**Bulletin # BU-4630**

## SAFETY BULLETIN

Ride Name: StarTrooper

**Abstract of Issue:** StarTrooper Lightning Bolt Sweep Light Cans.

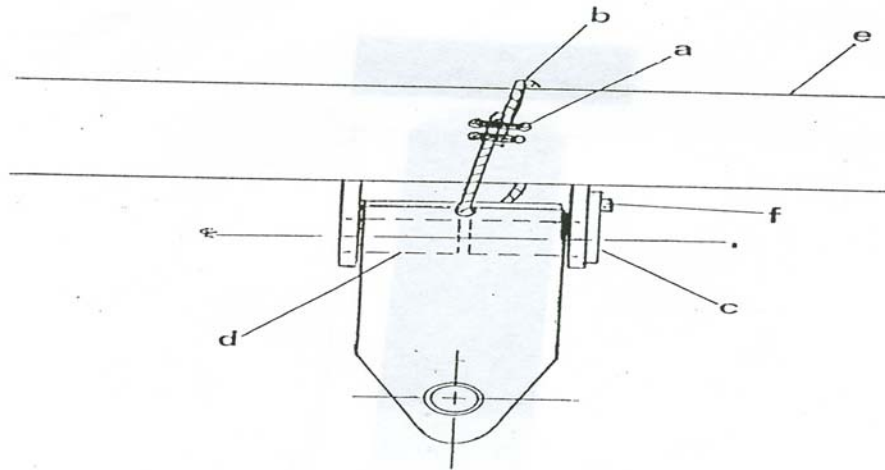
**Reason for release:** Because of a combination of factors, among them rough road conditions, one area of the StarTrooper lightning bolt sweep light cans is receiving a higher degree of stress than was expected. This can result in the partial failure of the welded joints, which could cause a lightning bolt to come off the ride during transportation or operation

**Action to be taken:** Dartron Industries, Inc requires that all StarTrooper's with serial #'s shown above inspect lightning bolt sweep light cans for structural cracks as shown in (fig 1). It is further recommended that all affected lightning bolt sweep light cans be reworked with the following reinforcement kit for added rigidity.

**Parts required:**

12	Gussets	5 3/8 x 13	#4630A
12	Gussets	4 5/8 x 13	#4630B
12	Gussets	3 3/4 x 6	#4630C
240	3/8 x 1 1/4	Hex Head Cap Screws	
264	3/8	Lock washers	
240	3/8	Nuts	
24	3/8 x 3/4	Hex Head Cap Screws	
540		Flat Washers
